City Council

November 18, 2025
Packet Addendum #2
11B_Coal Creek Village Public Comment

Major Issues with Coal Creek Development Plan

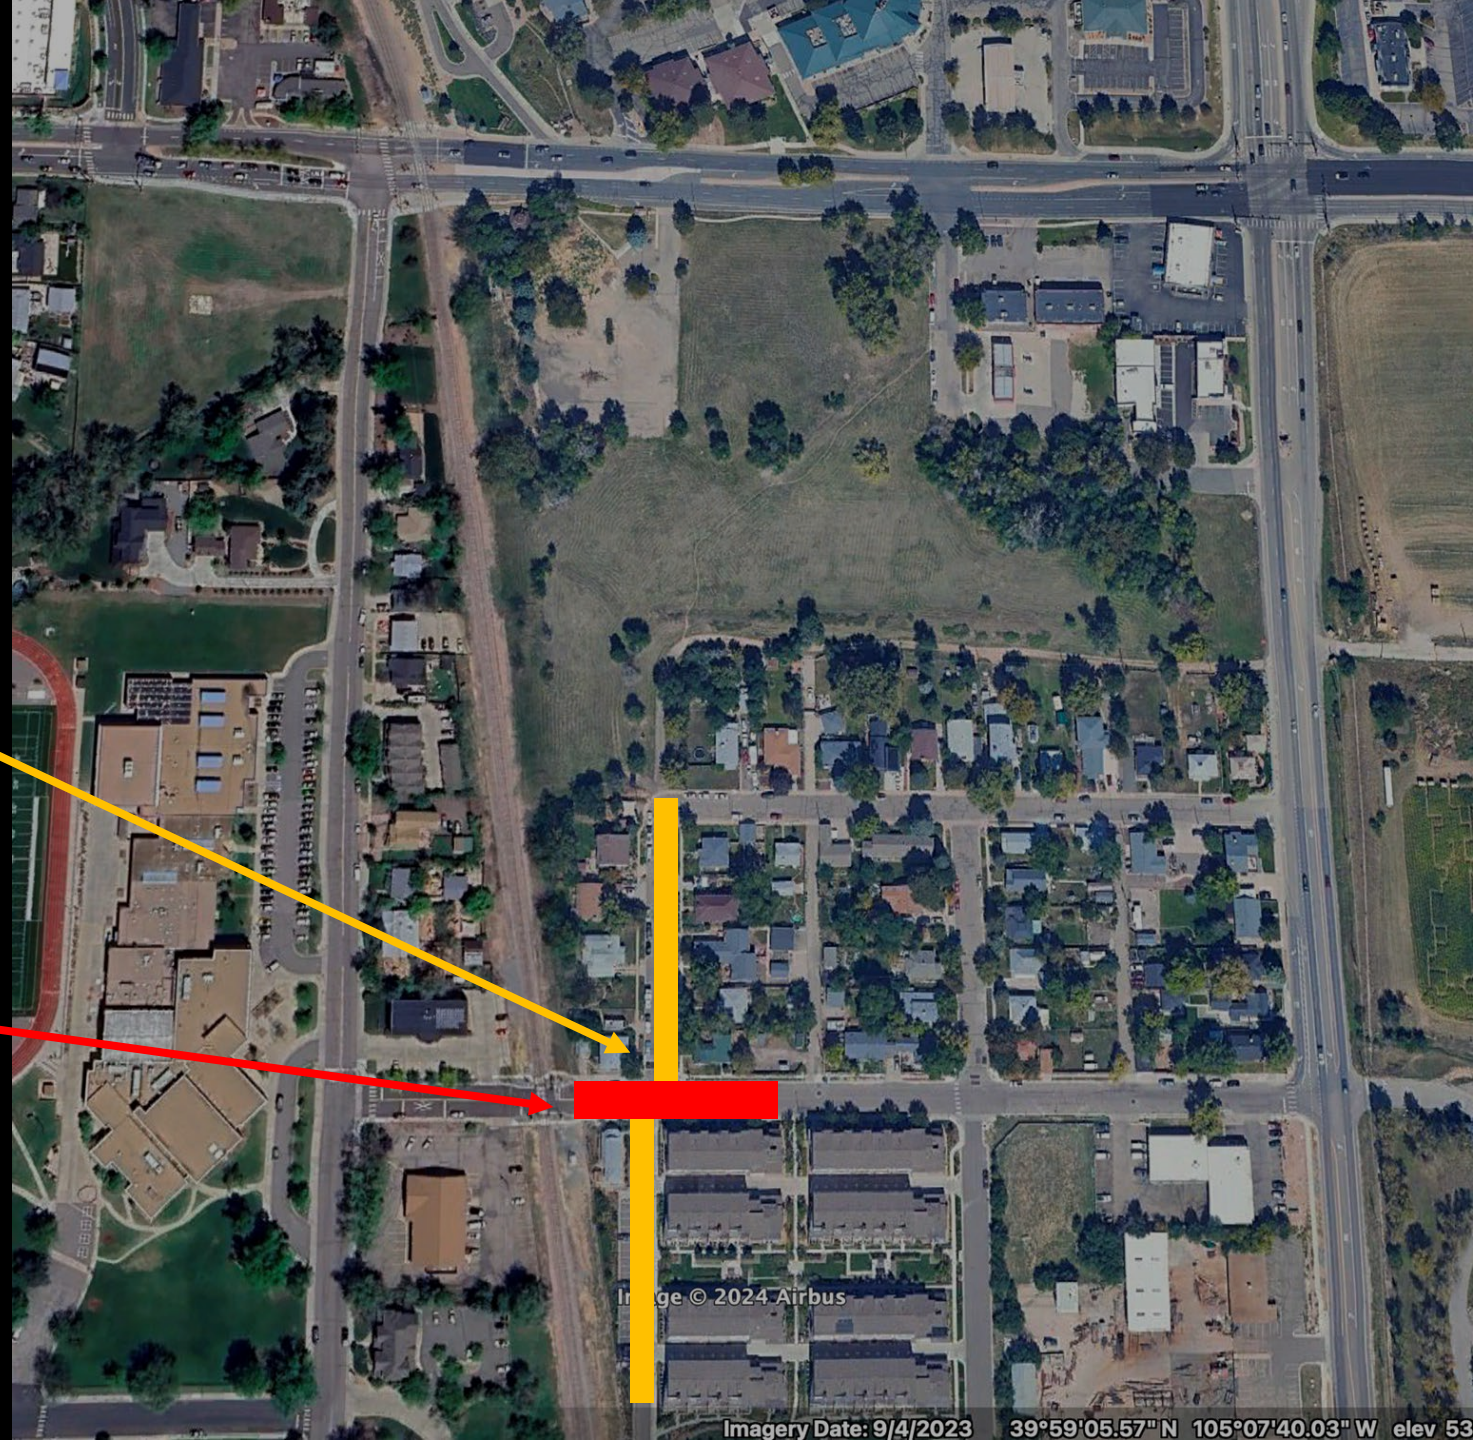
- Front St. cannot continue because of Delo development, offset and leads to parking lot for Delo
- Only takes 2-4 cars to block intersection at train crossing (already a problematic intersection for small neighborhood residents)

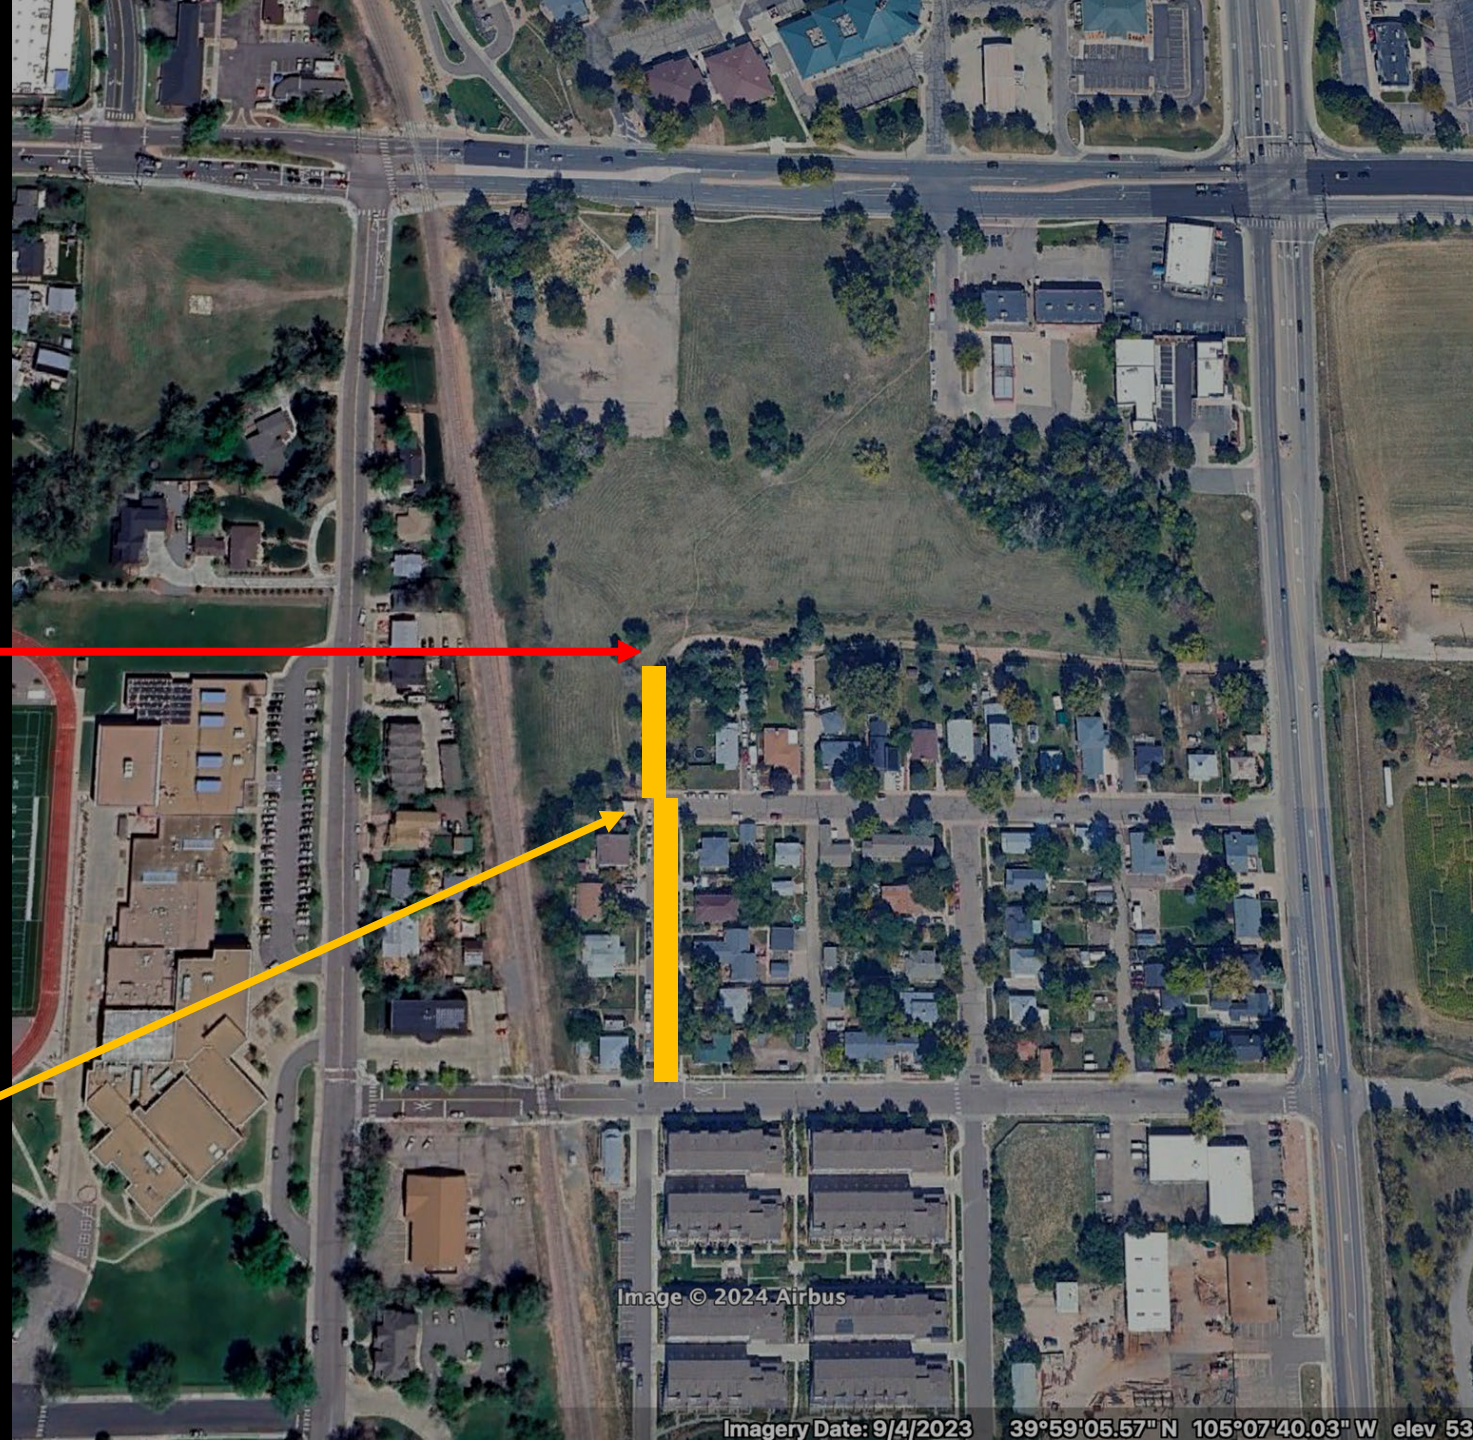
- Blocks existing resident access to their properties and garages (existing alley used and maintained for over 60 years by both city and residents)
- Offset due to a lack of land ownership north of Front St. blocks safe continuity of flow.

Developer's traffic study did not include this critical intersection

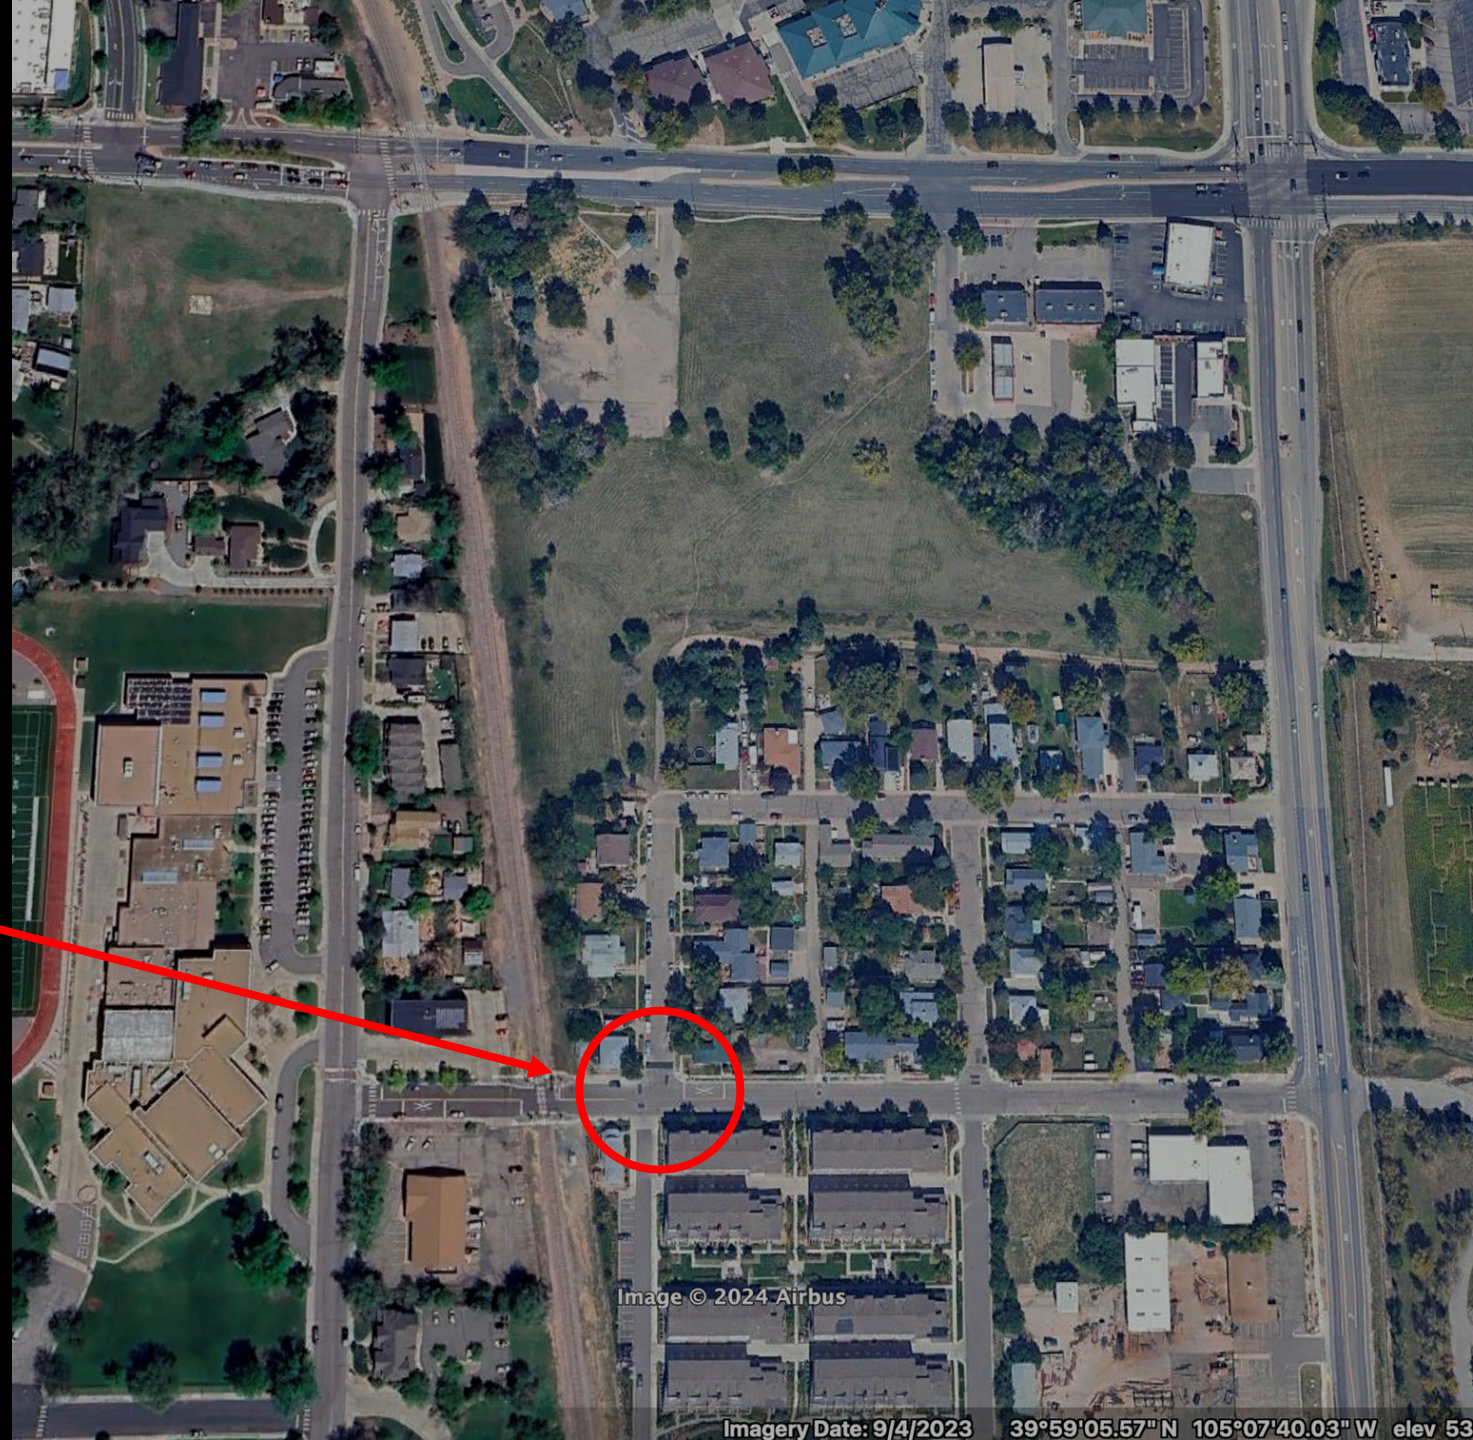
- Front St. and Griffith St. (clog point, railroad crossing, and major safety + traffic problem) not included in traffic study.
- Recent city investment in quieter train crossings did not anticipate routing thousands more cars/day through intersection.

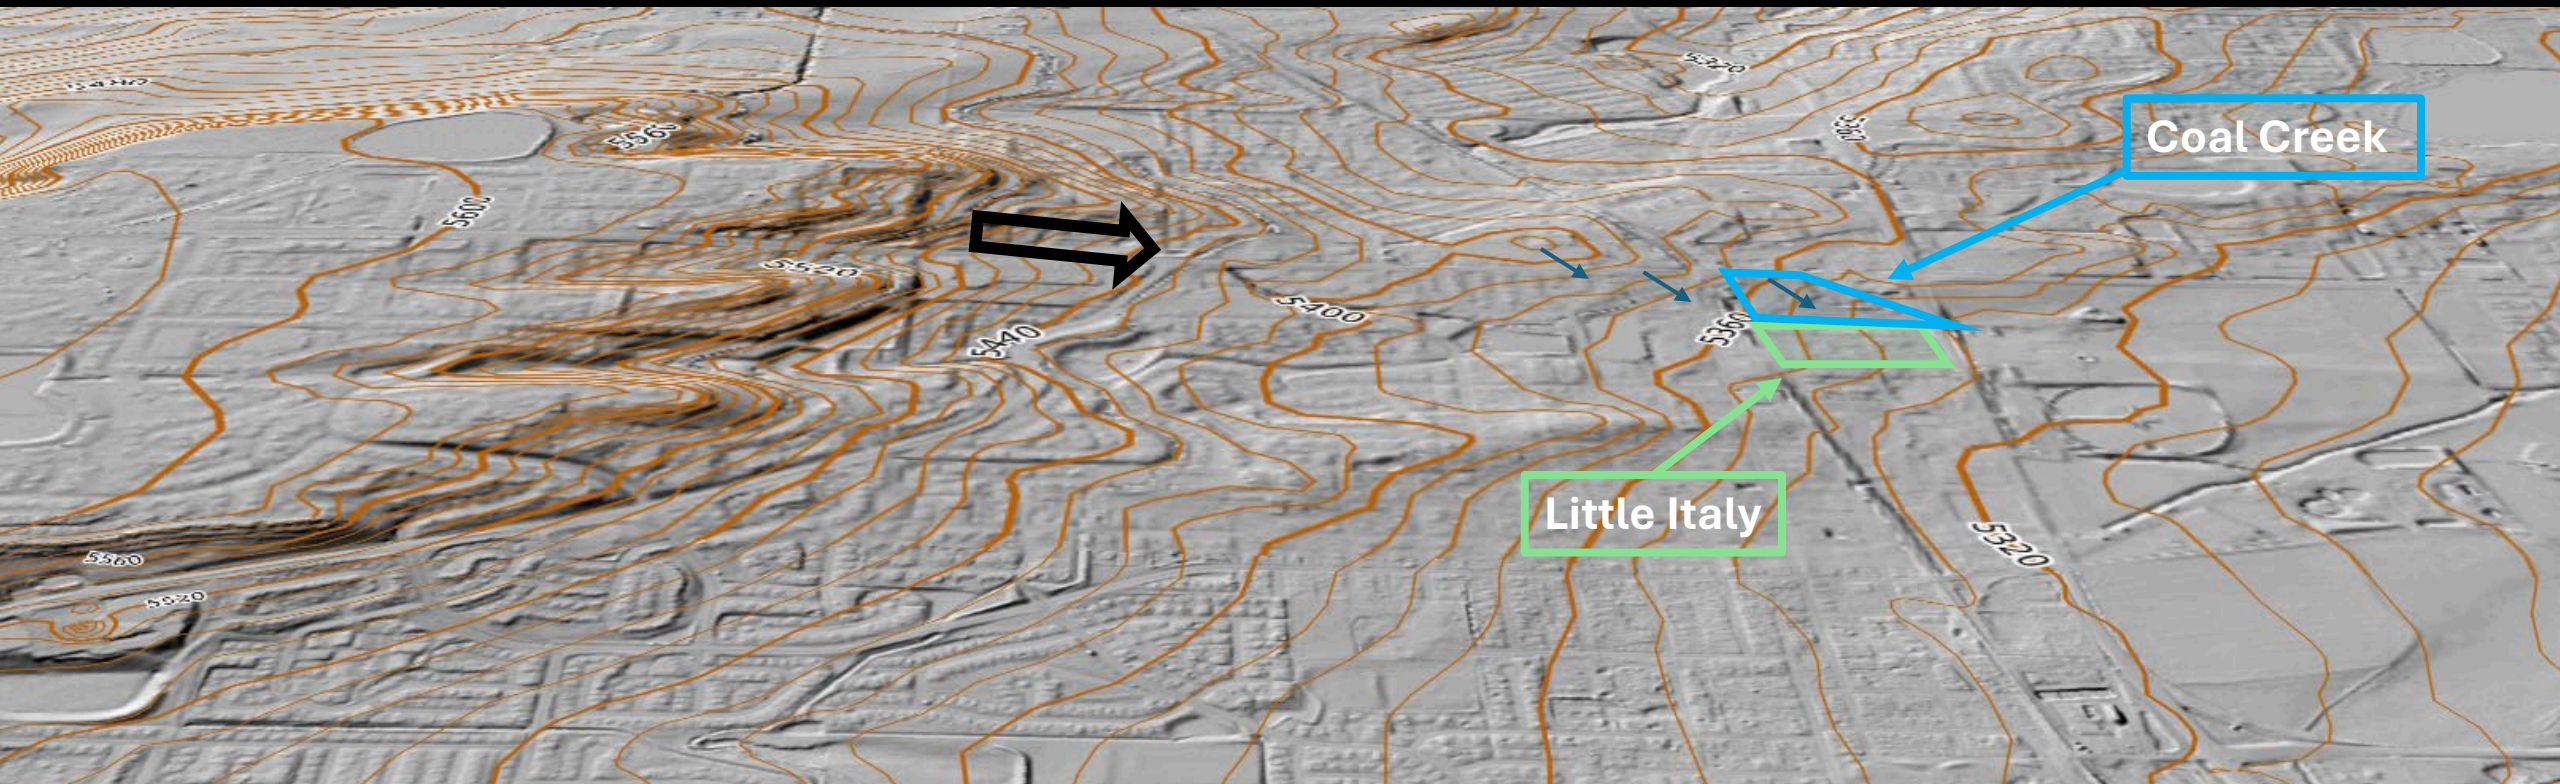
- PUD proposes routing all water TOWARDS Little Italy into underground storage, if these fail, historic houses built on cobbles/cinderblocks will be risked.
- Developer was unwilling to share flood engineering drawings with Little Italy residents.
- Additionally, sewer lines in Little Italy are only 10", and already have flood issues

Figure 9.

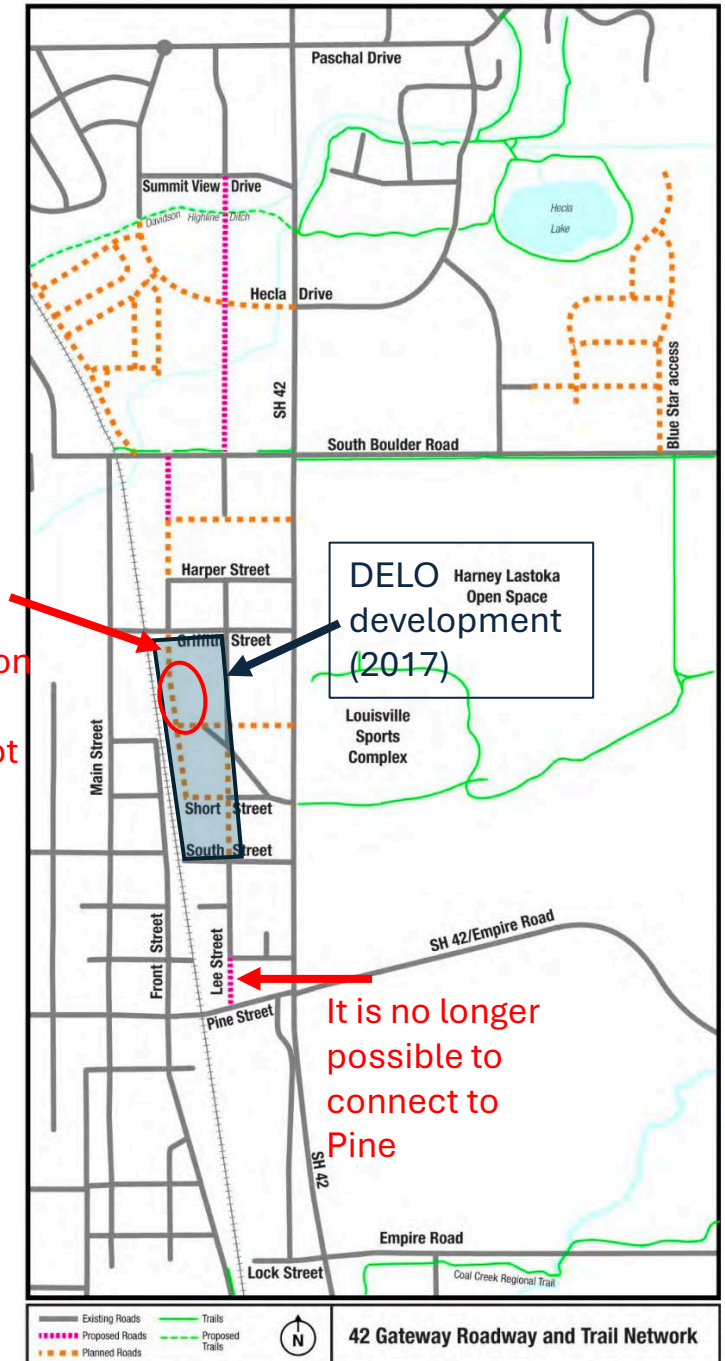
- But this plan DOES NOT EXIST since Delo was built – no grid, no way to connect to Pine/downtown anymore. Front St. is a SINGLE historic block, it does not provide gridded connectivity.
- The Front Street connection CAUSES safety concerns for schools, pedestrians, bikes (increase in traffic >900%), this is not a tradeoff for a 45% reduction in weave maneuvers on SBoRd. The intersection fails w/ or w/o connection (no city benefit/gain).

Delo
OFFSET
Front St.-
connection
goes to
parking lot
